State of New Mexico
Energy, Minerals and Natural Resources

SUNDRY NOTICES AND REPORTS ON WELLS
(DO NOT USE THIS FORM FOR PROPOSALS TO DRILL OR TO DEEPEN OR PLUG BACK TO A DIFFERENT RESERVOIR. USE "APPLICATION FOR PERMIT" (FORM C-101) FOR SUCH PROPOSALS.)

PROPOSED PLUG & ABANDONMENT

CONDITIONS OF APPROVAL FOR PLUGGING & ABANDONMENT

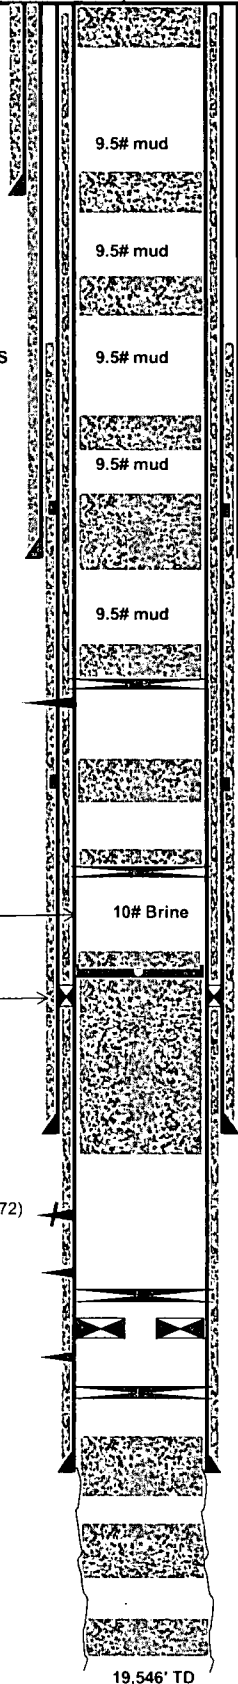
Proposed:
1. Spot 30 sx cmt from 120' to surf.
2. Cut wellhead off, set dry hole marker

Proposed:
Spot 40 sx (160') cmt @ 650'. Tag TOC. Calc. PBD @ 490'

Proposed:
Spot 40 sx (160') cmt @ 950'. Calc. PBD @ 790'
(Top of Salt @ 950')

Proposed:
Spot 60 sx (240') cmt @ 4,150'. Calc PBD @ 3,910'
(Base of Salt @ 4,115')

Proposed:
Spot 45 sx (180') cmt @ 4,415'. Tag TOC. Calc. PBD @ 4,235' (Top of Delaware @ 4,370')

Proposed:
Set CIBP @ 5,300'. Spot 30 sx (120') cmt.

Proposed:
Spot 30 sx (120') cement @ 7,500'

1. Produced water **will not** be used during any part of the plugging & abandonment operation.
2. Notify NMOCD Dist. 2 office at least 24 hrs before beginning work.

3. Closed Loop System is to be used for entire plugging operation. Upon completion, contents of steel pit are to be hauled to a permitted disposal location.

6. If work has not begun within 90 days of the approval of this procedure, an extension request must be filed, stating reason that well has not been plugged.

7. Every attempt must be made to clean the well bore out to below the perms, before any plugs can be set, by whatever means possible.
8. **Cement Retainers may not be used.**

9. Squeeze pressures are not to exceed 500 PSI, unless approval is given by NMOCD.
10. Plugs may be combined after consulting with and getting approval from NMOCD.
11. Minimum WOC time for tag plugs will be 4 Hrs.
